CHAMPION AEROSPACE, INC.
SERVICE LETTER

S.B. NUMBER: 28VS200Y4DH-24-04-001

SUBJECT: Electrical Power - DC Generation - Transformer Rectifier Unit (TRU) Fan Motor Upgrade

Figure 1. Original Fan Motor Assembly Removal

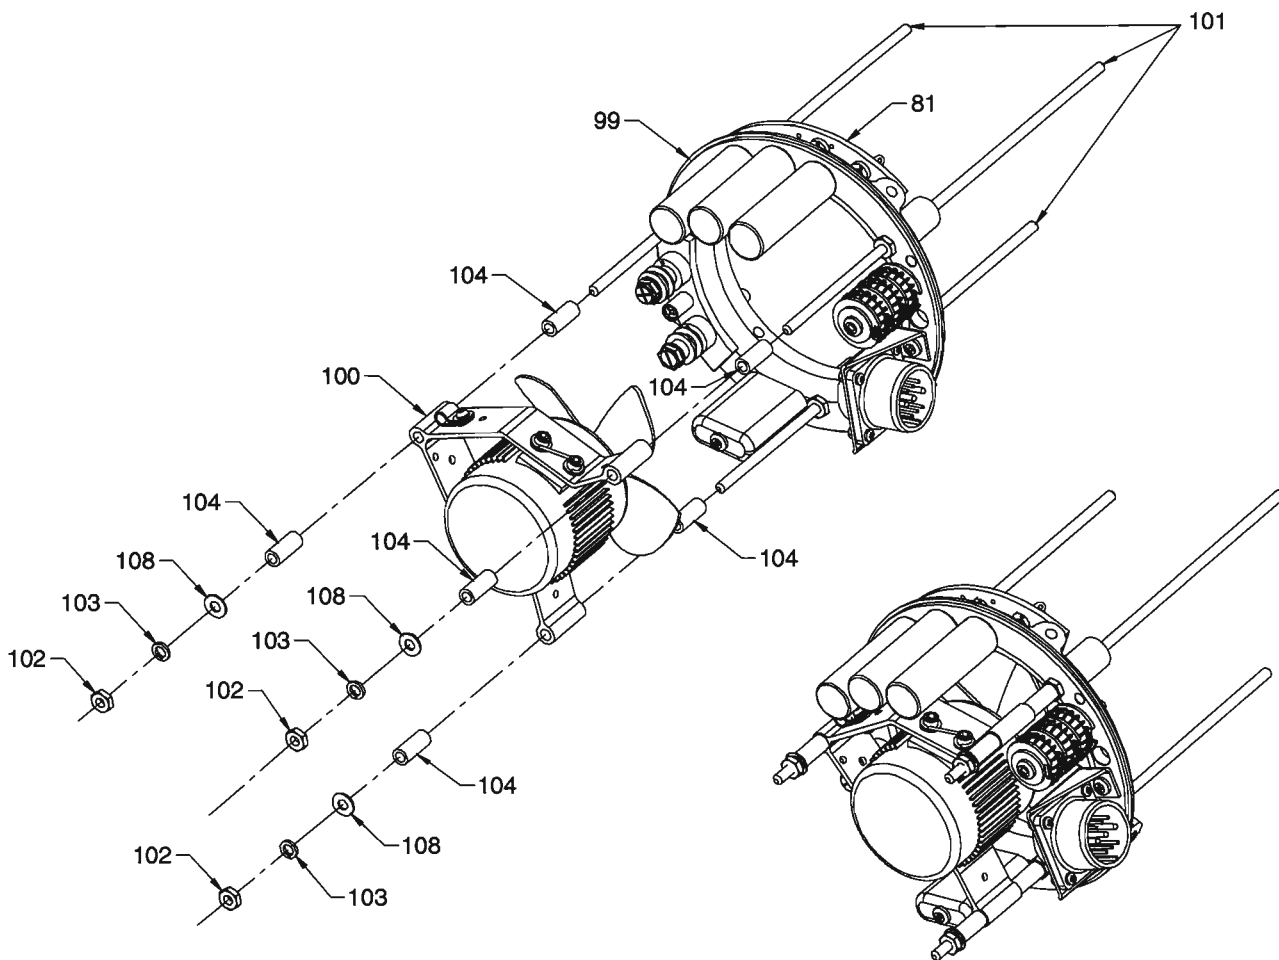
B. Disassembly - Remove Original Fan Motor Assembly (P/N:2561613).

NOTE: During removal of the original fan motor assembly, it is not necessary to remove the input connector (93) or the reactor (75).

- (1) Remove mounting base (3), end bell (1) and case assembly (6) in accordance with IPL, Figure 1 of component maintenance manual 24-31-46.
- (2) Remove original fan motor assembly (100) wire lugs (112) from AC Terminal Board (81).
- (3) Remove three nuts (102), three lockwashers (103), three flat washers (108) and three spacers (104) from original fan motor assembly (100) as illustrated in Figure 1.
- (4) Remove original fan motor assembly (100) from threaded tie bolts (101).
- (5) Remove remaining three spacers (104).

Figure 2. New Fan Motor Assembly Installation

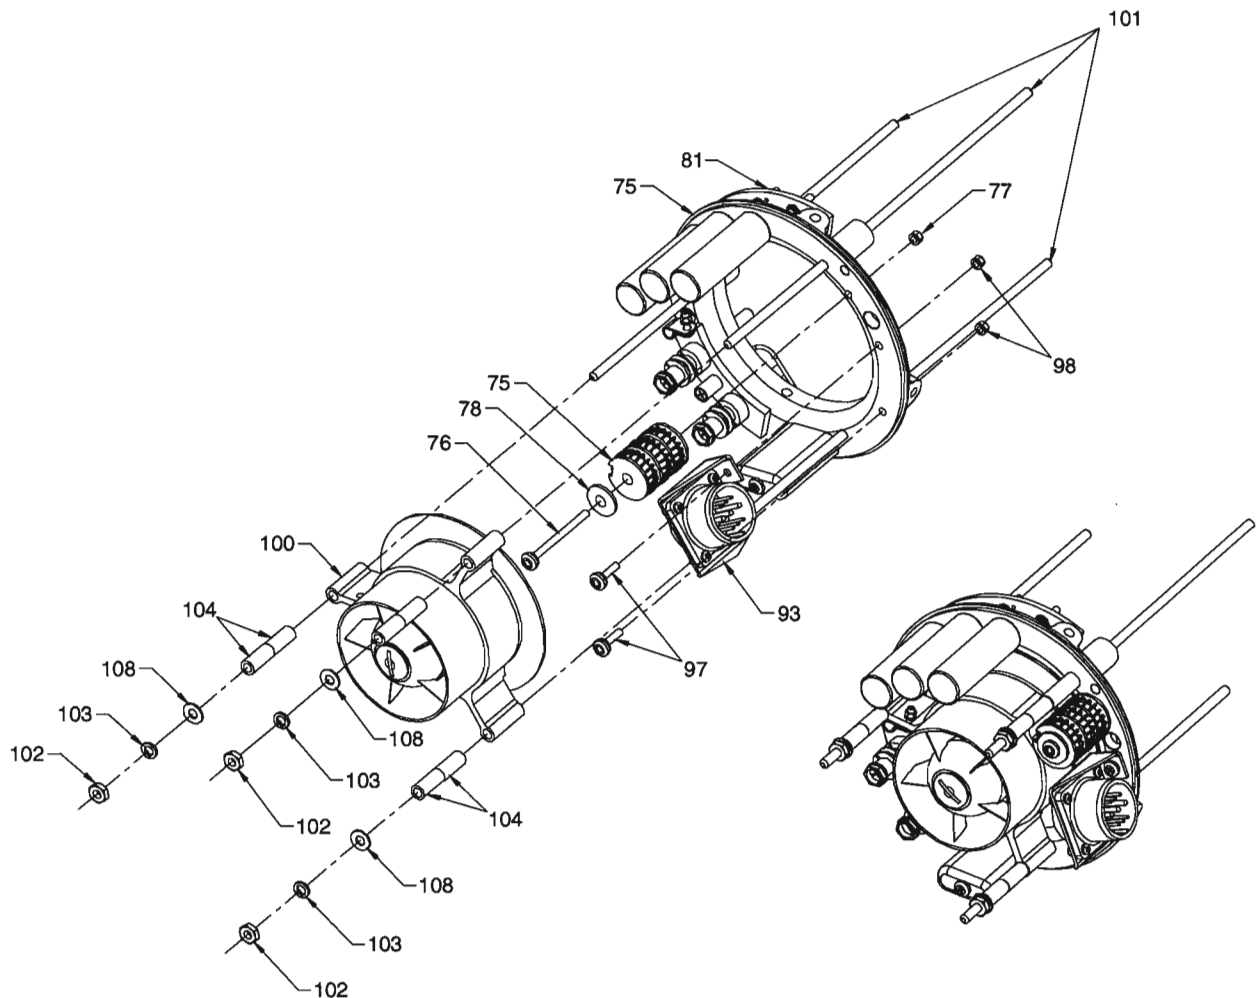
C. Assembly - Install New Fan Motor Assembly (P/N: 2031526).

NOTE: Prior to assembly of new fan motor assembly, it is necessary to remove the input connector (93) and reactor (75). Refer to Figure 2.

- (1) Remove two screws (97) and two nuts (98) securing input connector (93) to motor ring (99).
- (2) Remove input connector (93) and set aside.
- (3) Remove screw (76), washer (78) and nut (77) securing reactor (75) to motor ring (99).
- (4) Remove reactor (75) and set aside.

- (5) Install new fan motor assembly (100) (P/N: 2031526) onto threaded tie bolts (101).
- (6) Install six spacers (104), three flat washers (103), three lockwashers (108) and three nuts (102) onto threaded tie bolts (101) and secure until tight.
- (7) Install fan wire lugs (112) from new fan motor assembly (100) (P/N: 2561526), to AC terminal board (81). See Figure 3 for view of proper wire routing and termination.
- (8) Install mounting base (3), end bell (1) and case assembly (6) in accordance with IPL, Figure 1 of component maintenance manual 24-31-46.
- (9) Position reactor (75) onto motor ring (99) and install screw (76), washer (78) and nut (77) and tighten until secure.
- (10) Position input connector (93) onto motor ring (99) and install two screws (97) and two nuts (98) and tighten until secure.
